# Compton Community College District 1111 E. Artesia Blvd. Compton, CA 90221

- PROJECT: RFQ CCC-088 VAPA
- SUBJECT: ADDENDUM #1

# COMPTON COMMUNITY COLLEGE DISTRICT RFQ CCC-088 Visual and Performing Arts (VAPA)

### COMPTON COLLEGE STRUCTURAL UPGRADE OF REMAINING PORTIONS OF EXISTING BUILDING Y ADDENDUM 1 CONSOLIDATED CHANGES NARRATIVES

ISSU	E DESCRIPTION	
	DSA SUBMITTAL	01.17.2023
1	ADDENDUM 1	02.26.2025
SHEE	PLANTING	
	NOTES AND	
	SCHEDULE	
	JUNEDULE	
SHEE	TNUMBER	
	1 70	
	L70	UI
		-

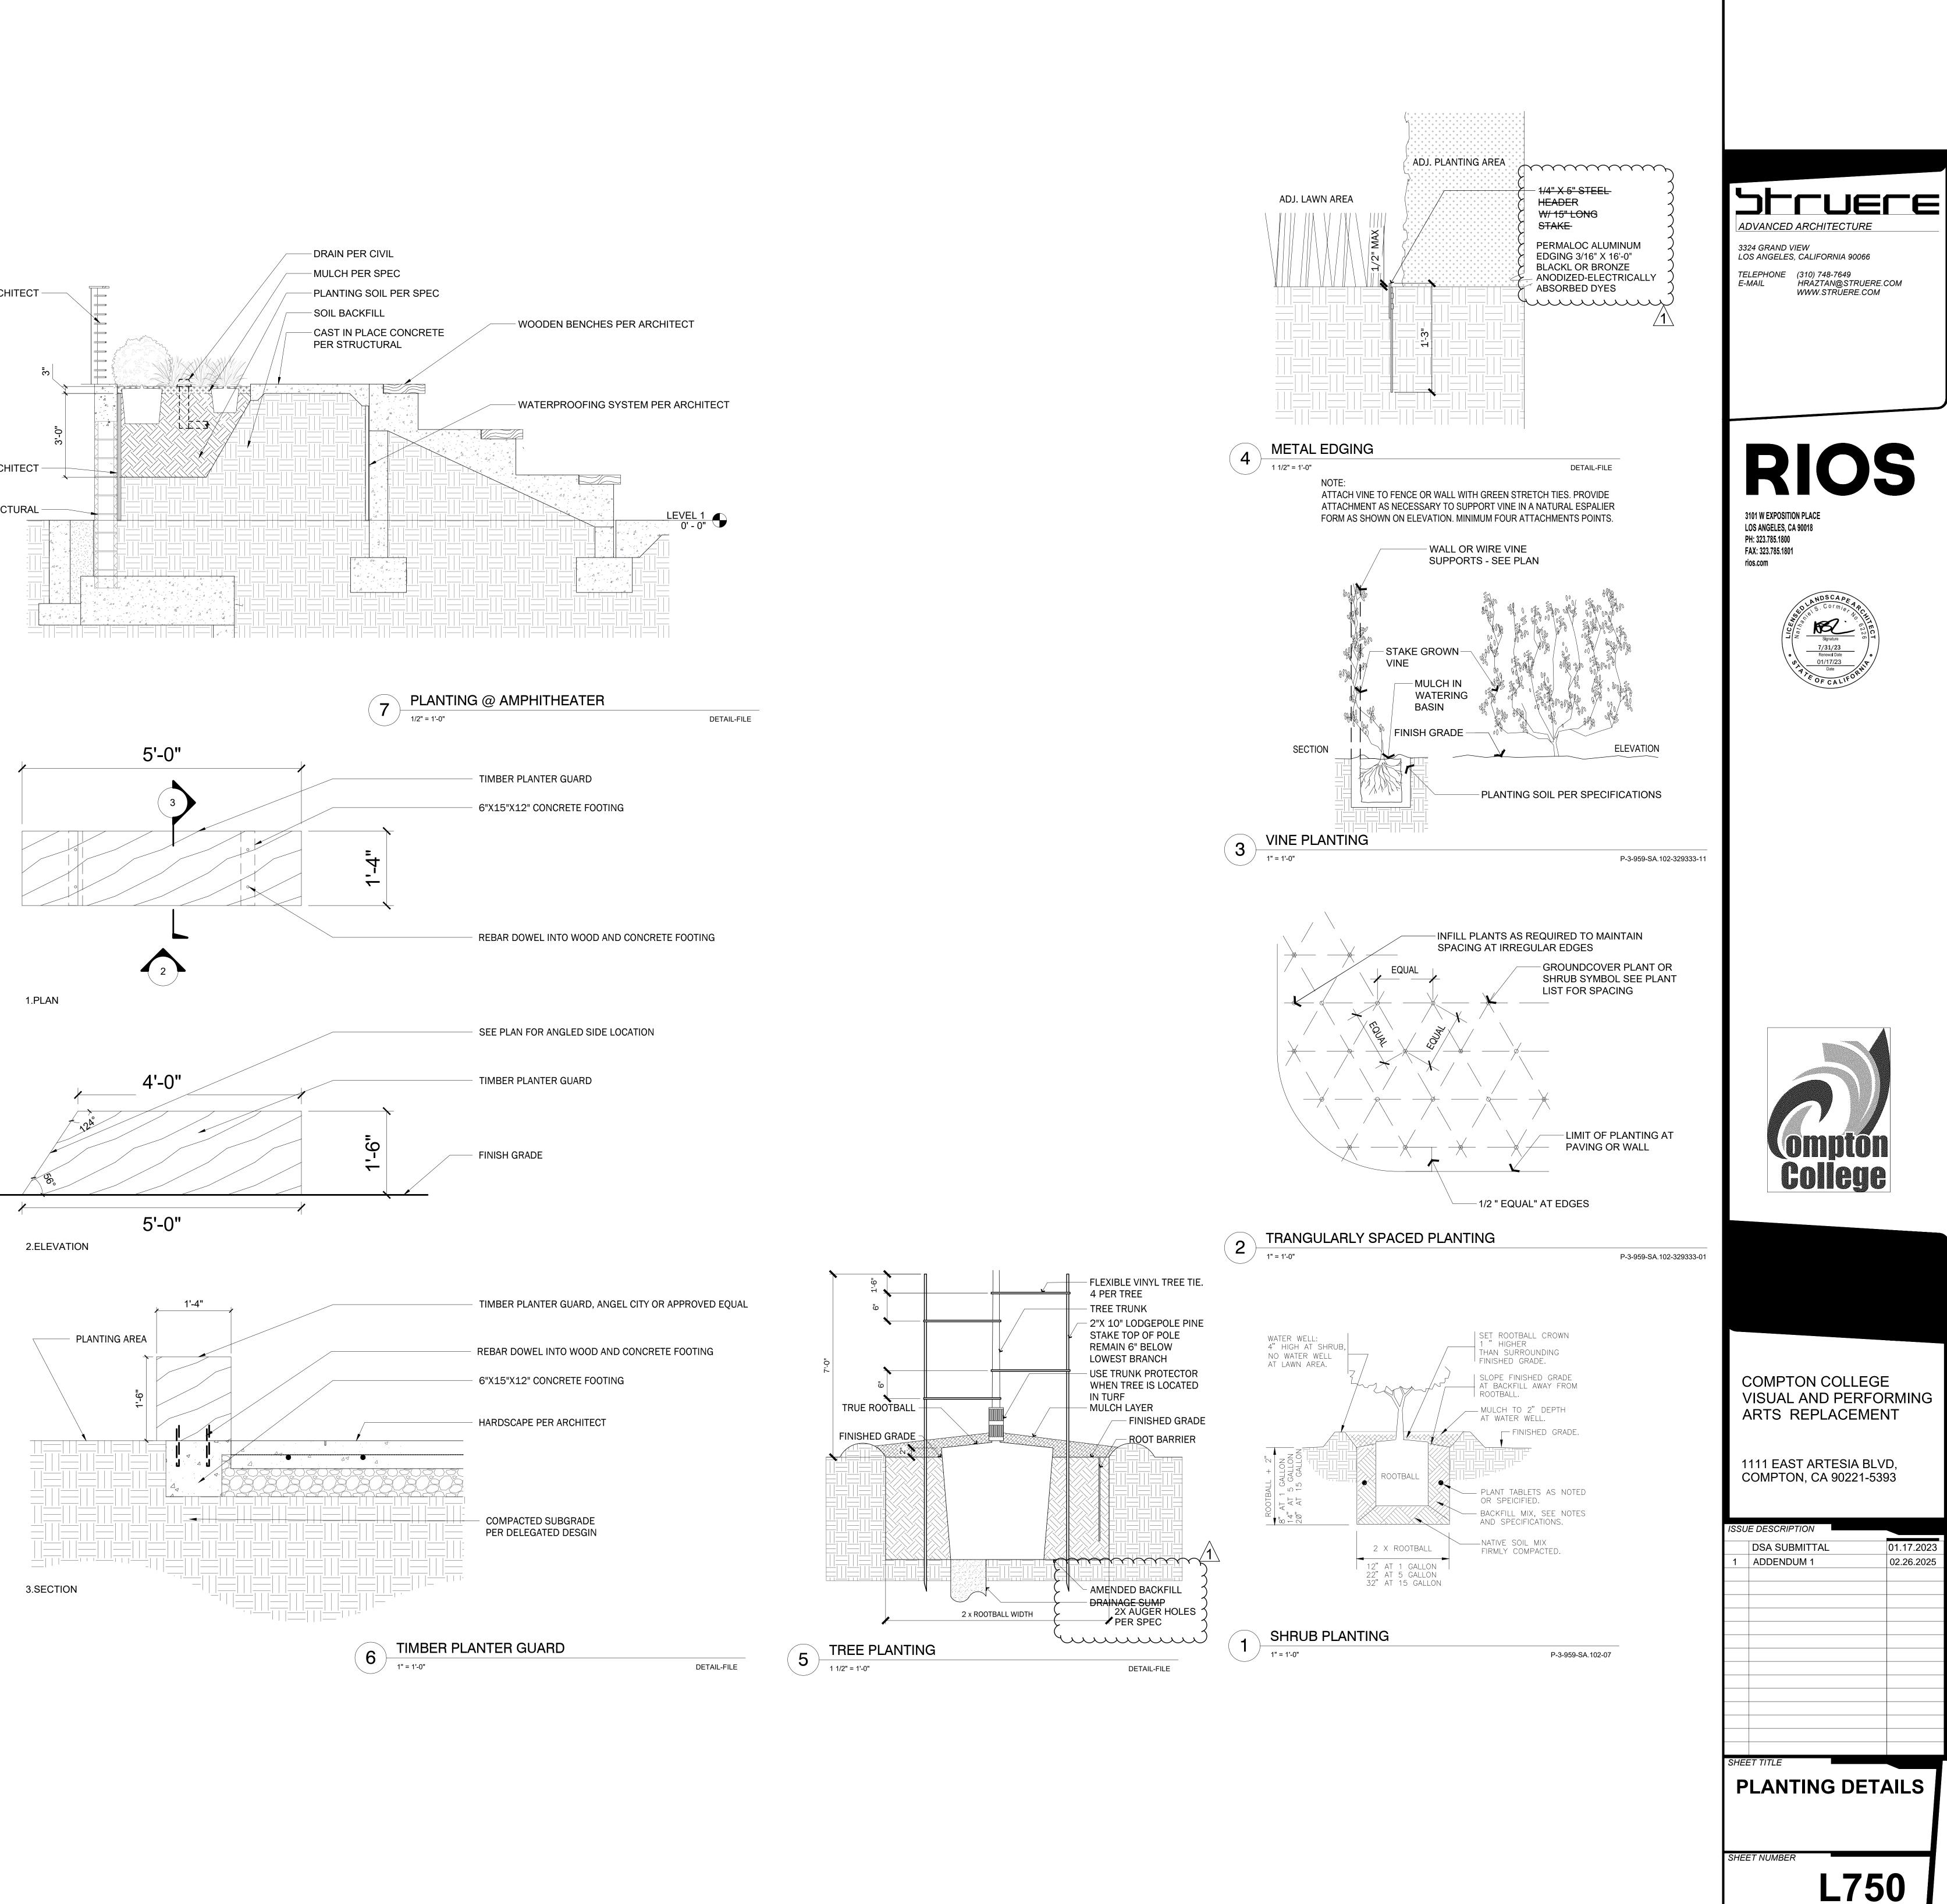
Per specs 329000/3, 3D, it shows ratios for backfiling shrubs. However, shrub planbting notes #6 on L700 shows "don not add amendments to the backfill soil, backfill the planting hole with excavated native soil". Please clarify.	L700	329000/3.3D	Follow Specification, drawing updated in Addendum 1. (RIOS)		
12	Per specs 329000/3, 3D7 it shows planting pits shall be backfilled with amended soil mix in 12" layer. However, tree planting notes #7 and shrub planting notes #6 on L700 show 'do not add amendments to the backfill soil, backfill the planting hole with excavated native soil or existing soil'. Please clarify.	L700	329000/3.3D	Follow Specification, drawing updated in Addendum 1. (RIOS)		
	Per spec 329000/2.1M it shows metal header is 'Permaloc Aluminum Edging 3/16" x 16'-0" Blackl or Bronze Anodized electrically absorbed dyes. However, detail 4 on L750 shows 1/4" x 5" steel header with 15" long stake. Please clarify.	L750	329000/2.1M	Follow Specification, drawing updated in Addendum 1. (RIOS)

Per specs 329000/3.3D5, it shows new trees and palms would be provided with 2 auger boles. However, detail 5 on L750 shows 1 drainage sump. Please clarify.	1750	329000/3.3D5	Follow Specification, drawing updated in Addendum 1. (RIOS)		
15	Per specs 329000/3.2, it shows soil preparation with 3 cy of organic amendment per 1,000 square feet. However, general note #25 on L700 shows compost for soil preparation is 4 cy per 1,000 square feet. Please clarify.	L700	329000/3.2	Follow Specification, drawing updated in Addendum 1. (RIOS)		
16	Per specs 328400/3.3, it shows sand backfill a minimum 4" pver and under all piping under paved areas. However, detail T on sheed KL621 shows sand backfill according to full depth of sleeve under paved areas, under sleeves are clean soil pipe bedding. Please clarify.	L621	328400/3.3	Follow Specification, drawing updated in Addendum 1. (RIOS)

LANDSCAPE		
L700 - PLANTING NOTES AND SCHEDULE	Change of annotation-Tree Planting Notes #7 to follow the specification section 32 90 00 3.3 D	
	Change of annotation-Shrub Planting Notes #6 to follow the specification section 32 90 00 3.3 D	
	Change of annotationShrub Planting Notes #6 and Tree Planting Notes #7 to follow the	
	specification section 32 90 00 3.3 D7	
	Change of annotation-General Notes #25 to follow the specification section 32 90 00/3.2	
L750 - PLANTING DETAILS	Change of detail #4 Metal Edging to follow the specification section 32 90 00/2.1 M	
	Change of detail #5 Tree Planting to follow the specification section 32 90 00/3.3 D5

A601

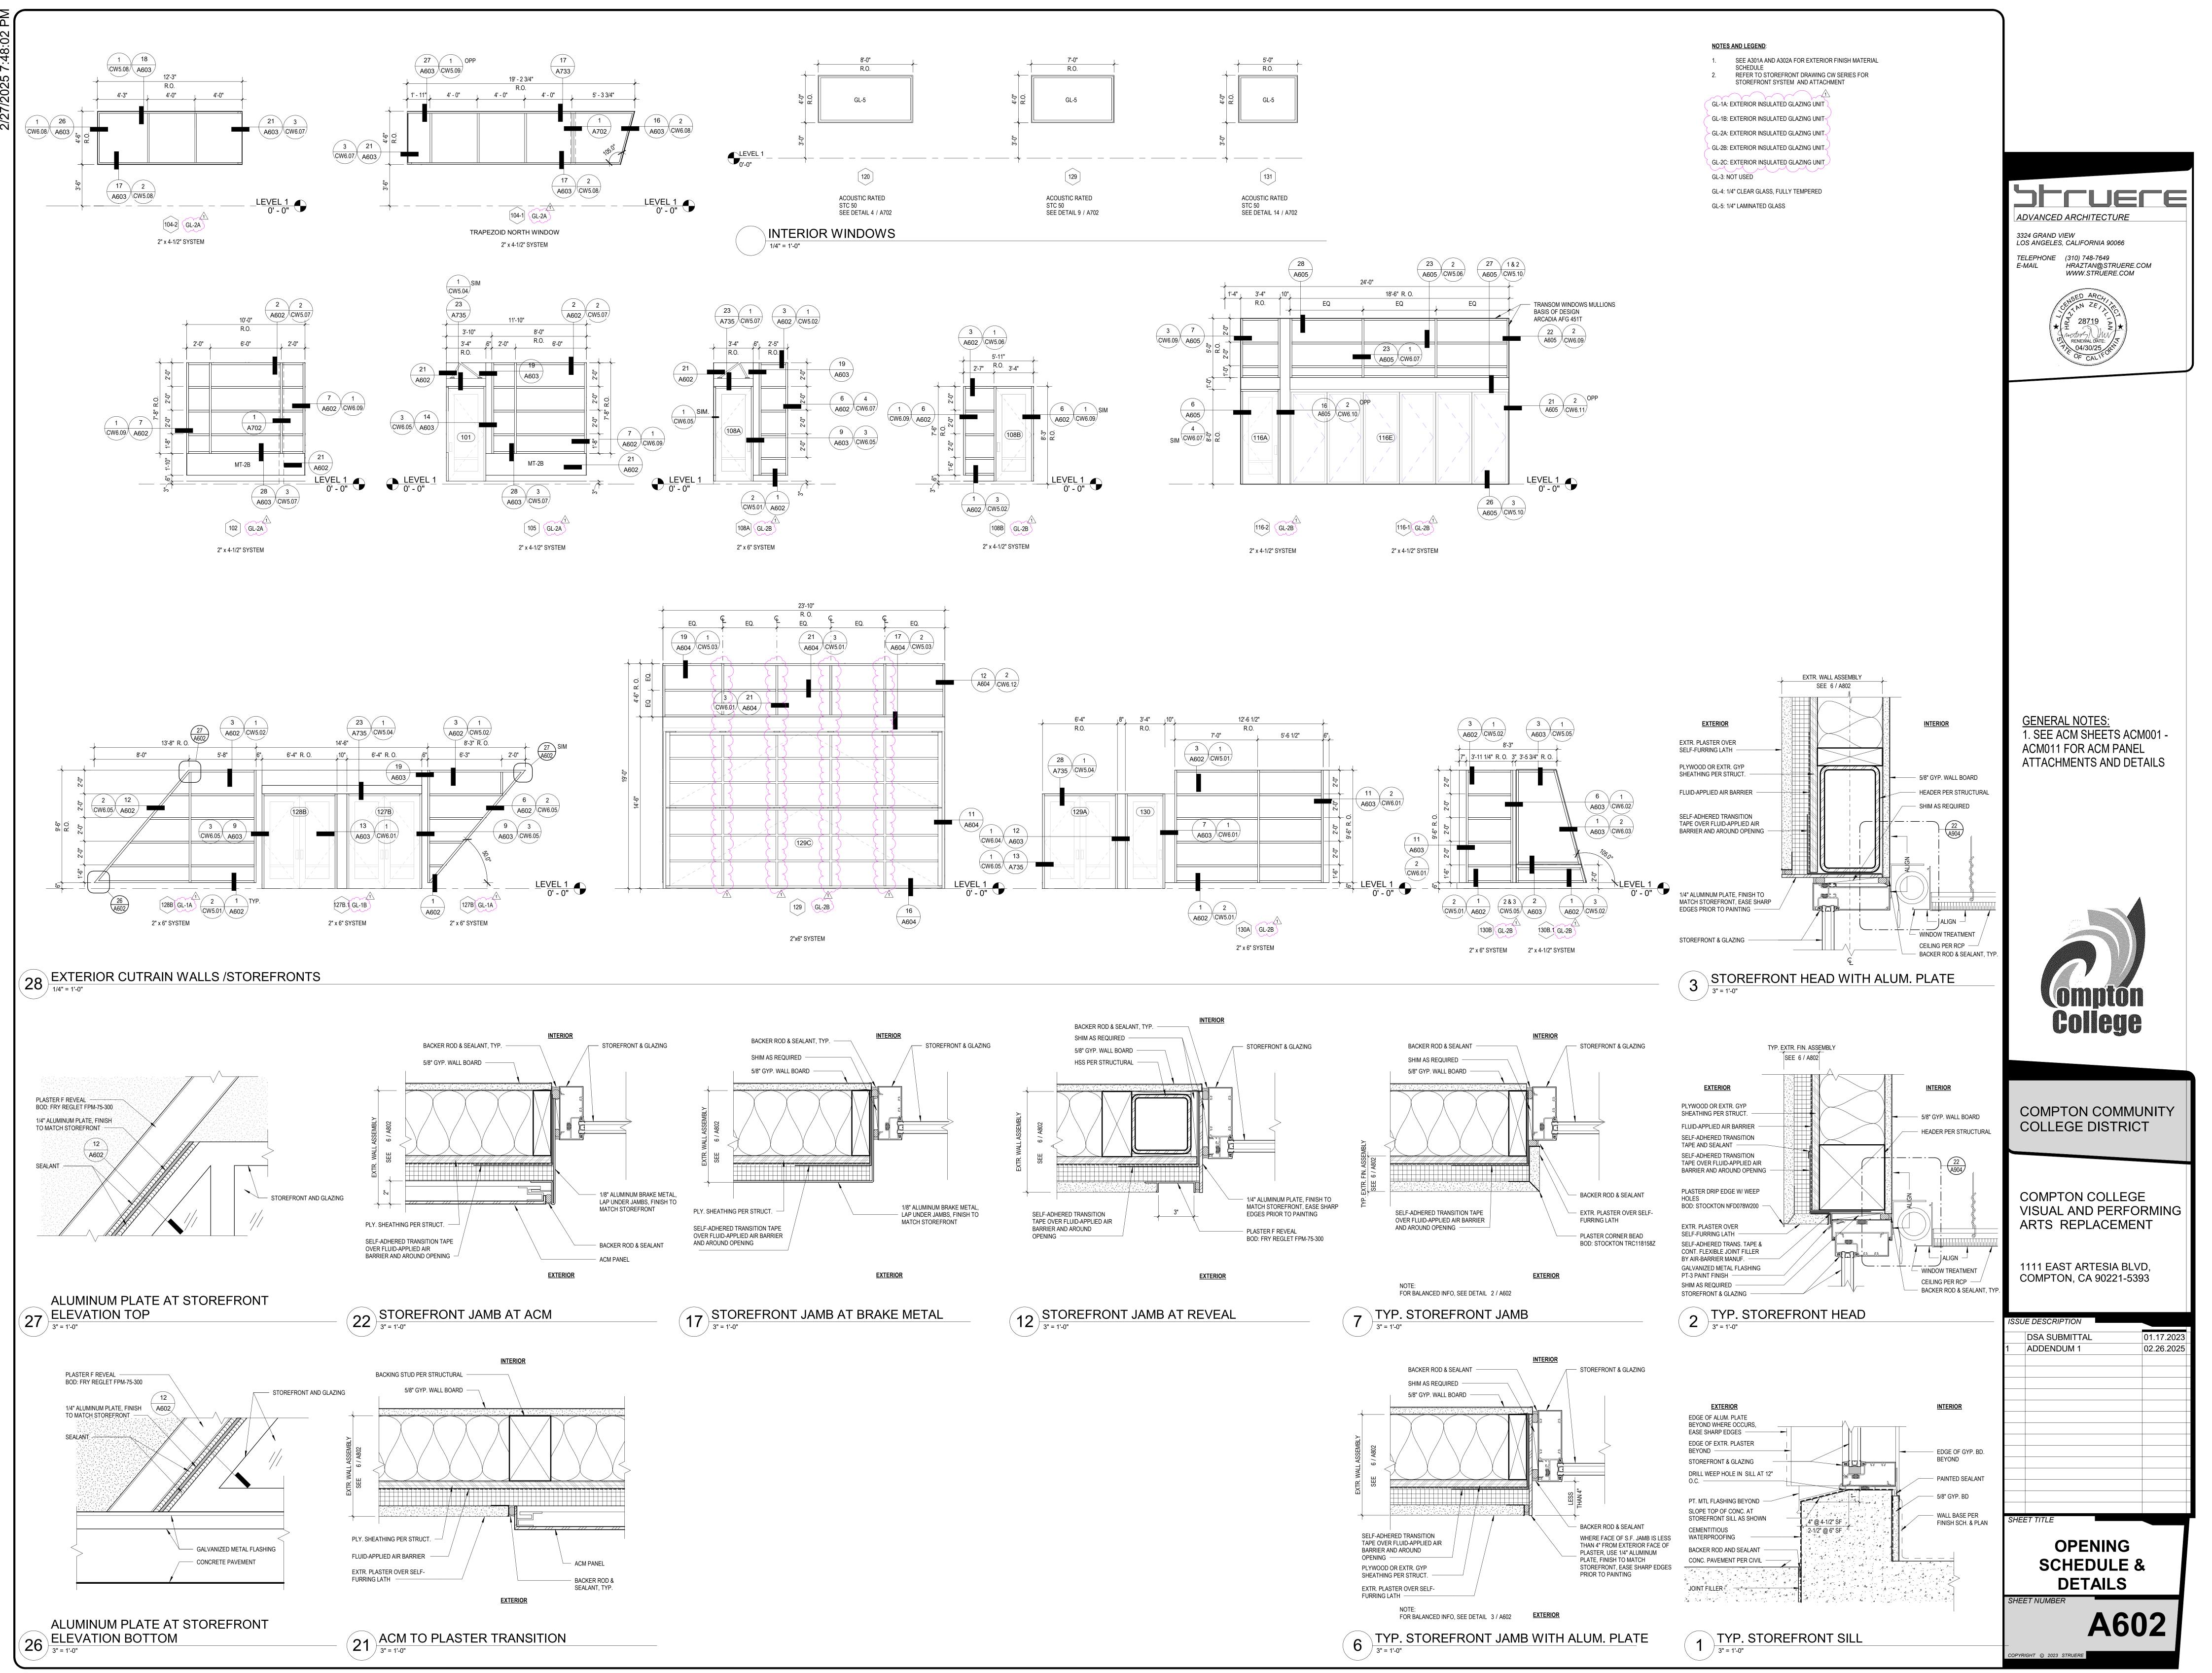
A411 - ENLARGED RESTROOM PLANS	Shower Curtains and Hooks product info added to legend, "NIC" removed.
A412 - RESTROOM ELEVATIONS	Shower Curtains and Hooks product info added to legend, "NIC" removed.
A601 - DOOR SCHEDULE & DETAILS	Glass types updated in door schedule // One horizontal mullion added to all full height glass doors
	// Two vertical mullions added at bi-fold door
A602 - OPENING SCHEDULE & DETAILS	Glass types updated // Two vertical mullions added at bi-fold door and the window above it
A610 - INTERIOR FINISH MATERIALS	DRP-1 and DRP-2 added // Minor finish information updates to MS-1, MS-2, MS-3, and IPT-5
A701 - PARTITION TYPES	Detail 3 graphics adjusted to show wall framing continuing beyond ceiling to clarify that the wall
	does not stop at the ceiling // Tag for already existing 8/S011 added to detail 3 for added clarity
A904 - INTERIOR DETAILS - CEILING	Mecho shade identification tags "(MS-#)" added to the titles of details 6, 10, 21, and 22 for clarity
